Attachment B4

Selected drawings

PROJECT NAME
420 KENT ST

DRAWING TITLE
ELEVATION - PUBLIC DOMAIN - NORTH OPEN SCREENS & GLAZING

DRAWING NUMBER
DA2008

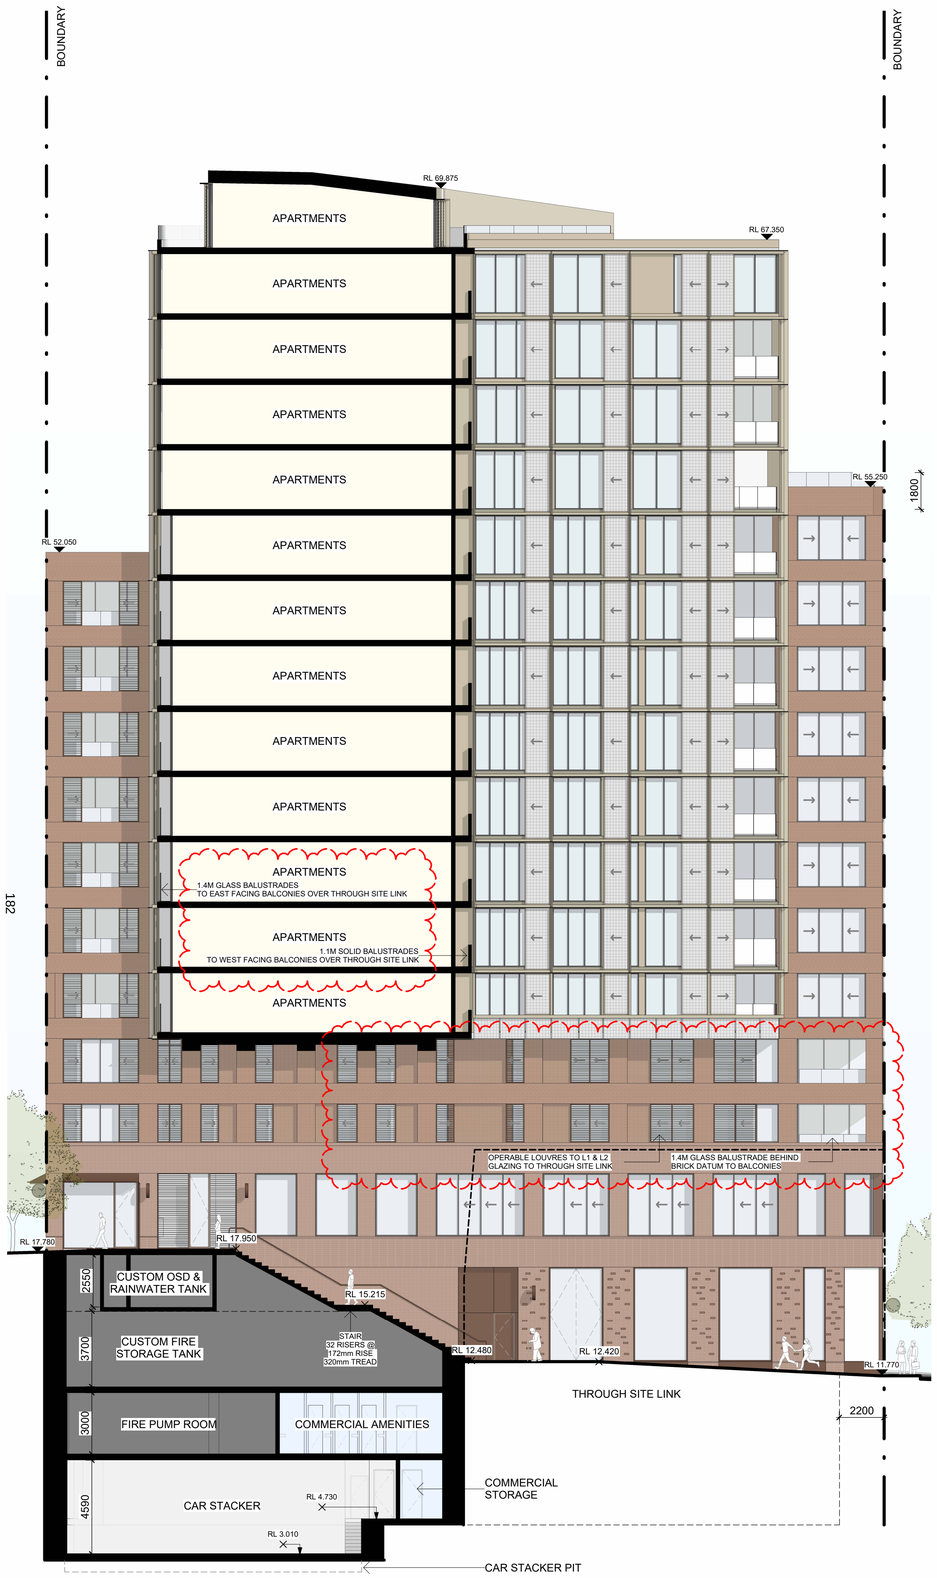
ACOUSTIC AND VENTILATION UPDATE:

ALL RESIDENTIAL WINTERGARDENS CONVERTED TO BALCONIES IN LINE WITH ACOUSTIC REPORT TYPES & REQUIREMENTS. MINOR BALUSTRADE AND GLAZING OPERABILITY ADJUSTMENTS TO SUIT.

NATURAL VENTILATION CALCULATION BASED ON ADG OBJECTIVE 4B-1, USING THE EFFECTIVE OPENABLE AREAS OF WINDOWS AS DEFINED IN THE GLOSSARY OF THE ADG (PLEASE SEE DIAGRAM BELOW).

- NATURAL VENTILATION CALCULATION ASSUMES SCREENS IN OPEN POSITION.
- ALL WINDOW OPENINGS NOT FACING ONTO A BALCONY ARE RESTRICTED TO 125MM MAX OPENING.

DRAWING NUMBER
DA2202

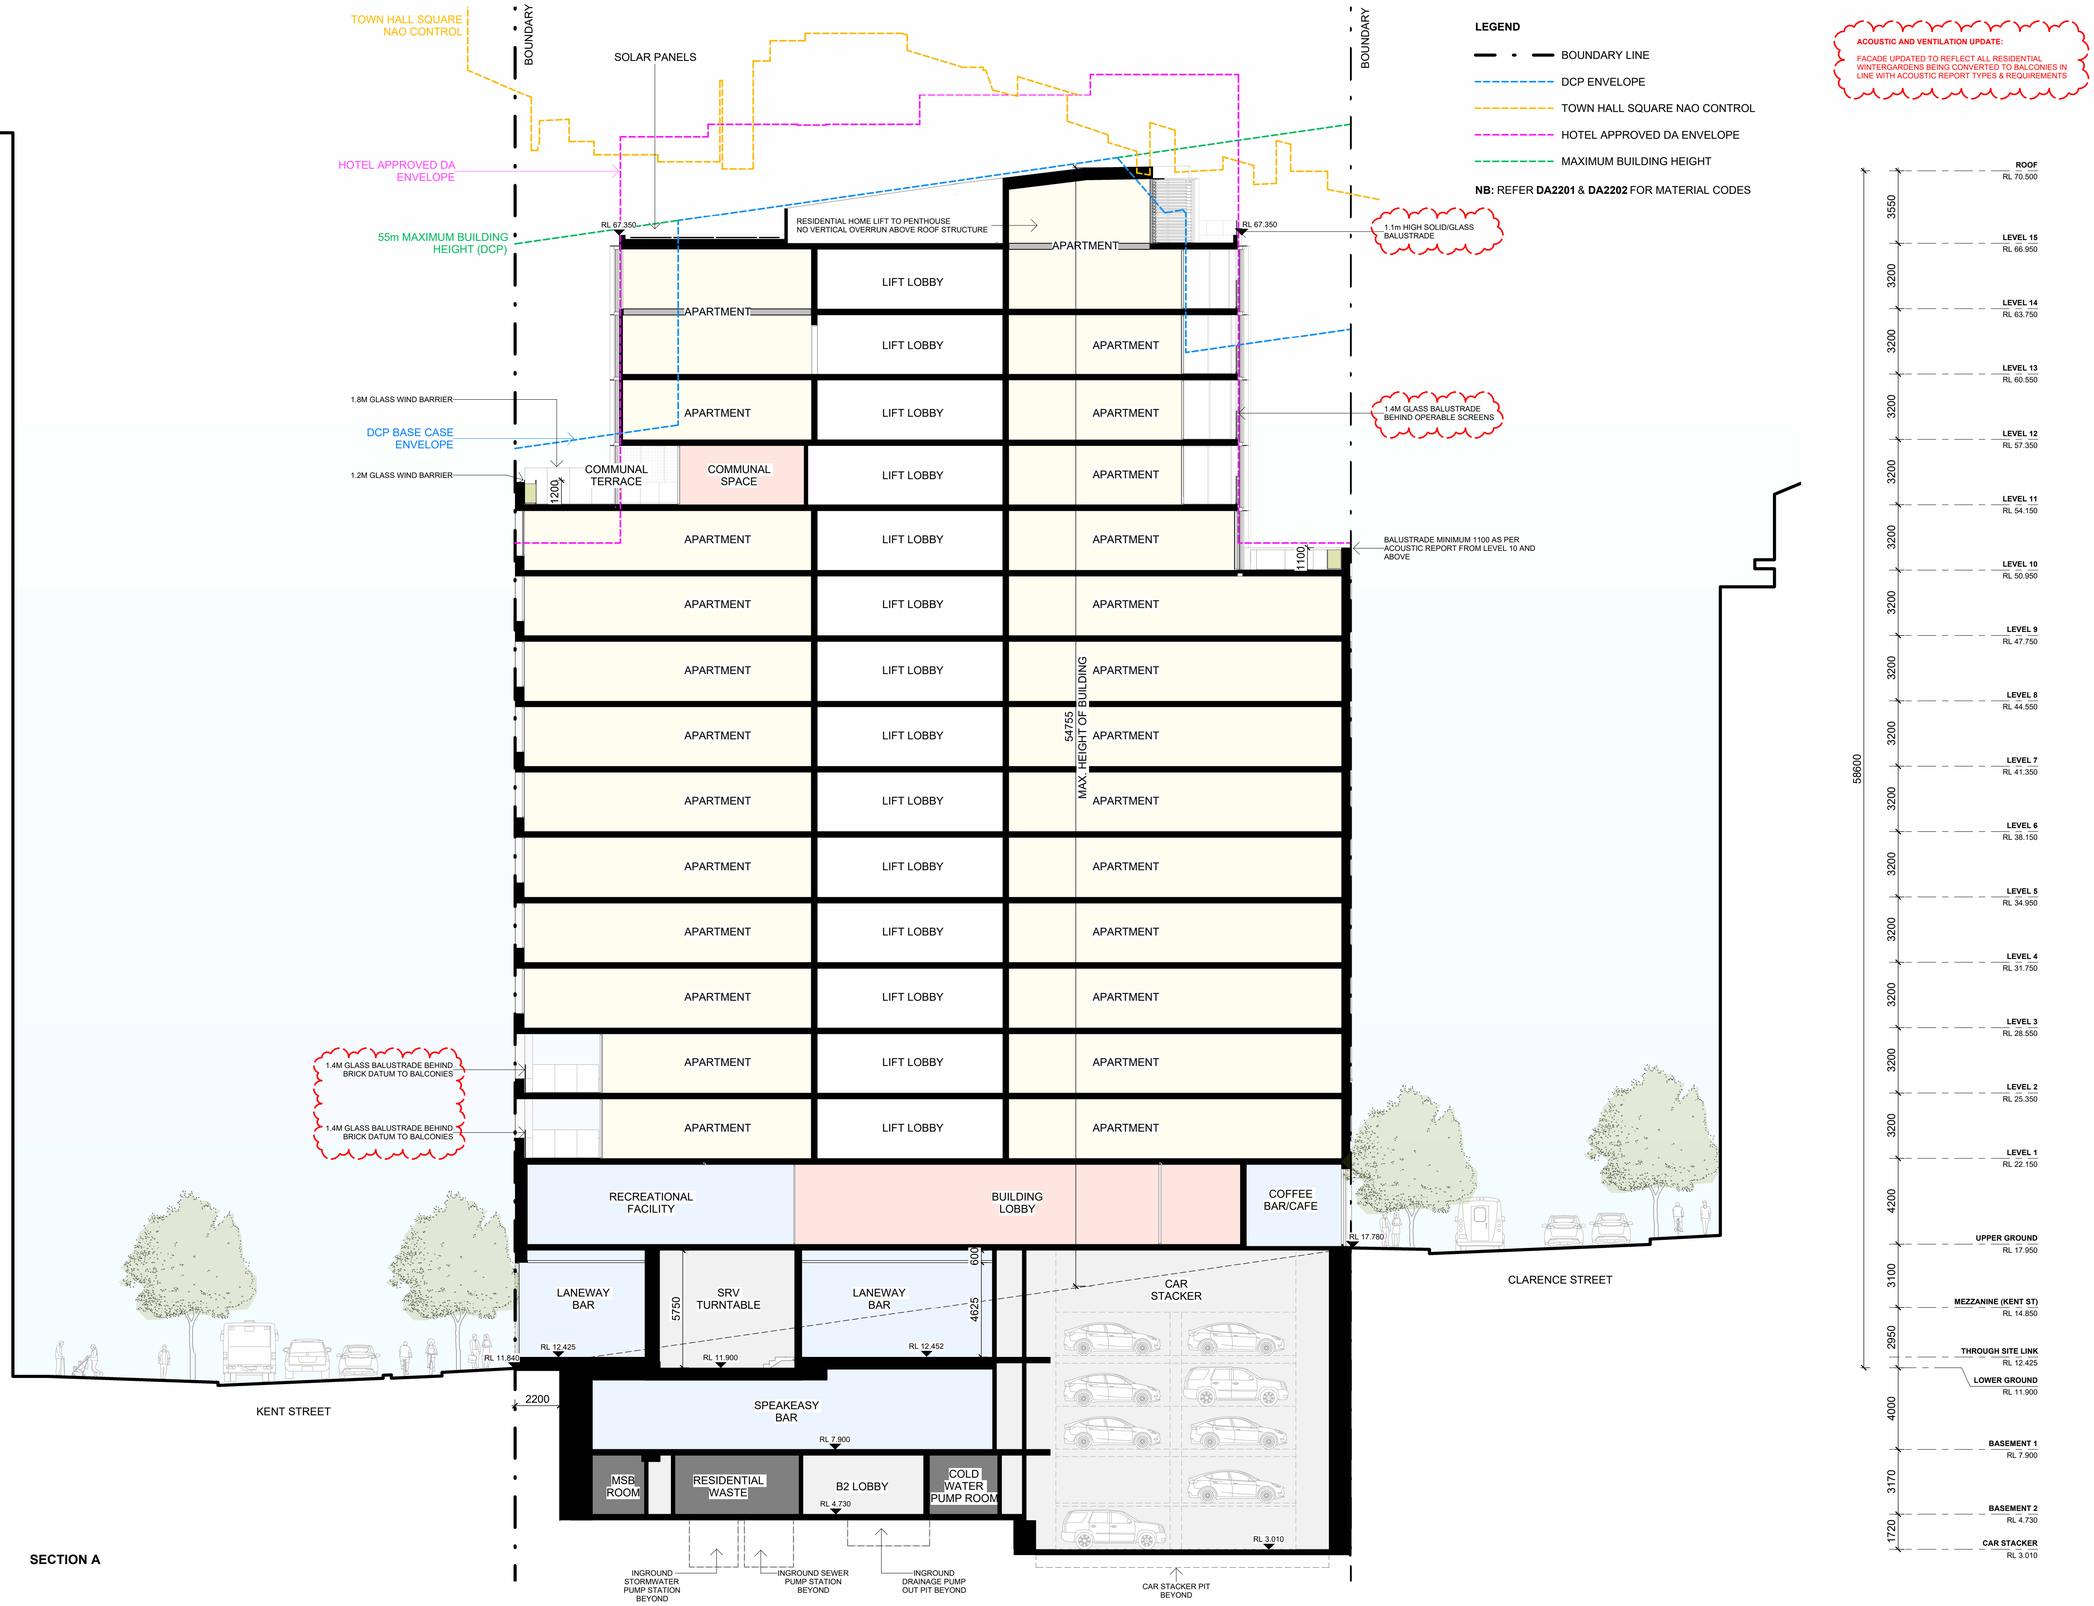
ACOUSTIC AND VENTILATION UPDATE:

FACADE UPDATED TO REFLECT ALL RESIDENTIAL WINTERGARDENS BEING CONVERTED TO BALCONIES IN LINE WITH ACOUSTIC REPORT TYPES & REQUIREMENTS
